Design & Access Statement The Gatehouse, Mayfair Mews NW1 8UU

27/02/2017

Amenity

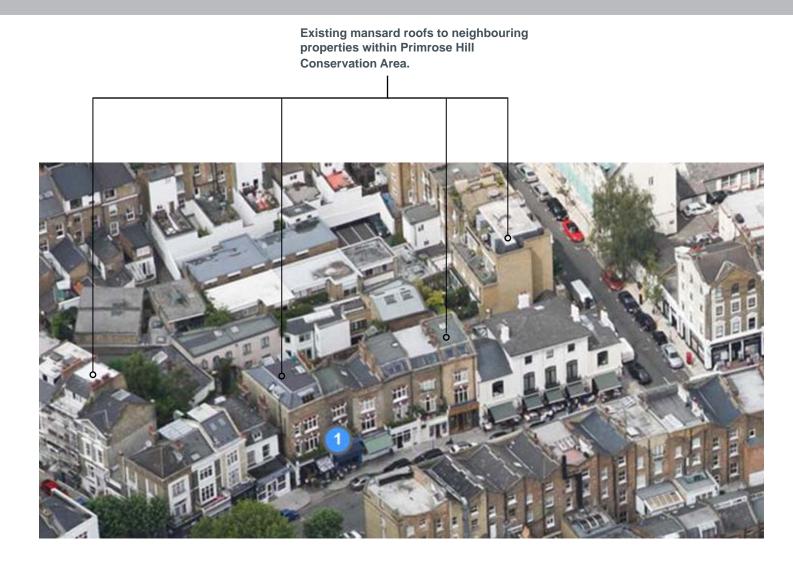
- The roof extension may have an impact on daylight/sunlightlevels currently enjoyed at no 1 Erskine Mews. A daylight/ sunlight impact assessment should be submitted. A daylight/ sunlight impact assessment forms part of the application. A daylight/ sunlight study has been carried out by Right Of Light Consulting on 22 February 2017. The study confirms that the proposed development satisfies all of the requirements set out in the BRE guide 'Site Layout Planning for Daylight' and Sunlight'.

-The rear window may result in the loss of privacy. This should be designed to protect the amenity of the neighbour's proporty and as discussed with the agent it is recognised and obscured glazing would be proposed. *The rear window will have obscured glazing to protect the amenity of the neighbour's property.*
